### Historic Architectural Review Commission Staff Report for Item 3

To:	Chairman Haven Burkee and Historic Architectural Review Commission Members
From:	Enid Torregrosa-Silva, MSHP
	Historic Preservation Planner
Meeting Date:	July 23, 2024
Applicant:	Bone Island Roofing, Contractor
Application Number:	H2024-0025
Address:	402 South Street

Replace metal shingles with 5 V-crimp on an existing roof of a contributing building.

Detail of existing roofing. Photograph provided by applicant.

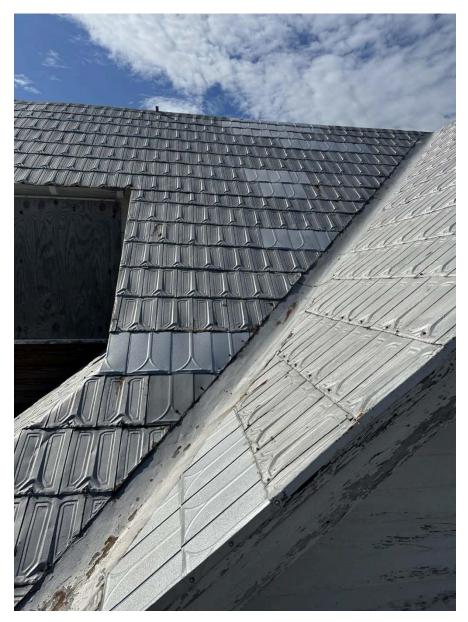
The Certificate of Appropriateness under review proposes the removal of all shingles over the cross-gable roof and their replacement with 5 V-crimp. Staff explained to the applicant about economic hardship ordinance for substitute materials and gave him the documents for it, but according to him the owners do not qualify for it. The house orientation is north- south, and different from 404 South Street, the house is exposed to South Street on its northwest elevation. In 2009 the Commission approved the replacement of metal shingles with 5 V-Crimp "because of special circumstances because the property faces a southern exposure, and it is open to water".

It is staff's opinion that the request to replace metal shingles with 5V-crimp material fails to follow the cited guidelines. If the Commission determines that there is a hardship due to the southern exposure of portions of the house staff recommends the use of metal shingles in the façade facing South Street, which is not exposed to the Atlantic Ocean. The roof design will allow to split materials.
